Access Compliance Report Public Rights-of-Way (Curb Ramps)

Intersection ID: 47452 Main Street: WHISTLING SWAN RD **Cross Street: MALLARD LANDING RD** Location: SE **ADA ID: 8A8D78EFC517** Ramp Type: PerpDiag Initial Pass/Fail: Fail **Overall Compliance: No Severity Score:** 25

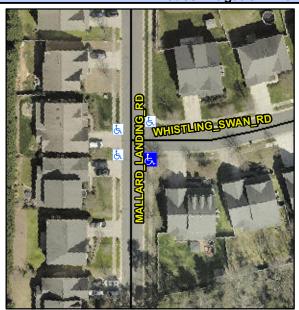
Possible Solutions: Remove & Replace Curb Ramp With Two New Directional Ramps or Equivalent. Surveyor Notes: N/A PROW/ADA: Not Found, R304.2.2, R304.5.3

Field Measurements/Component Compliance							
C	Compliance Description		Data	Comp	oliance	Description	Data
N/	A Ramp I	Length (in)	46.0	No	Ram	Slope (%)	8.5
Υe	s Ramp	Width (in)	48.0	No	Ram	XSlope (%)	5.4
N/	A Flare T	ype LT	N/A	N/A	Flare	Type RT	N/A
N/	A Flare S	Slope LT (%)	N/A	N/A	Flare	Slope RT (%)	N/A
N/	A Flare T	raversable LT?	N/A	N/A	Flare	Traversable RT?	N/A
N/	A Landing	g Length (in)	N/A	N/A	DWS	Provided?	N/A
N/	A Landing	g Width (in)	N/A	N/A	DWS	Contrast?	N/A
N/	A Landing	g Slope (%)	N/A	N/A	DWS	Length (in)	N/A
N/	A Landin	g X Slope (%)	N/A	N/A	DWS	Full Width?	N/A
N/	A Landing	g Curb? (Y/N)	N/A	N/A	DWS	Offset (in)	N/A
N/	A Shared	Landing?	N/A				
N/	A Gutter	Ponding?	N/A	N/A	Gutte	er Slope (%)	N/A
N/	A Gutter	Lip Ht (in)	N/A	N/A	Gutte	er X Slope (%)	N/A
N/	A Painted	d X Walk1?	No	N/A	Paint	ed X Walk2?	No
	X Walk	1 Direction	To NE		X Wa	lk 2 Direction	To NW
N/	A X Walk	1 Width (in)	N/A	N/A	X Wa	lk 2 Width (in)	N/A

X Walk	1 Slope (%)	0.0		X Wa	lk 2 Slope (%)	3.9
	X Walk	1 X Slope (%)	5.5		X Wa	lk 2 X Slope (%)	2.5
N/	A Ramp i	nside XWalk1?	N/A	N/A	Ram	o inside XWalk2?	N/A
	Road S	Slope (%)	5.1	N/A	Clear	Space?	N/A
	Road X	(Slope (%)	3.1	N/A	Clear	Space to XWalk (in)	N/A
N/	A Any Ob	ostructions?	N/A	N/A	Storn	n Grate/Utility Hazard?	N/A
	Obstru	ction Type			Storn	n Grate/Utility Type	
			N/A				N/A
				Yes	Surfa	ce Condition? (G/P)	Good
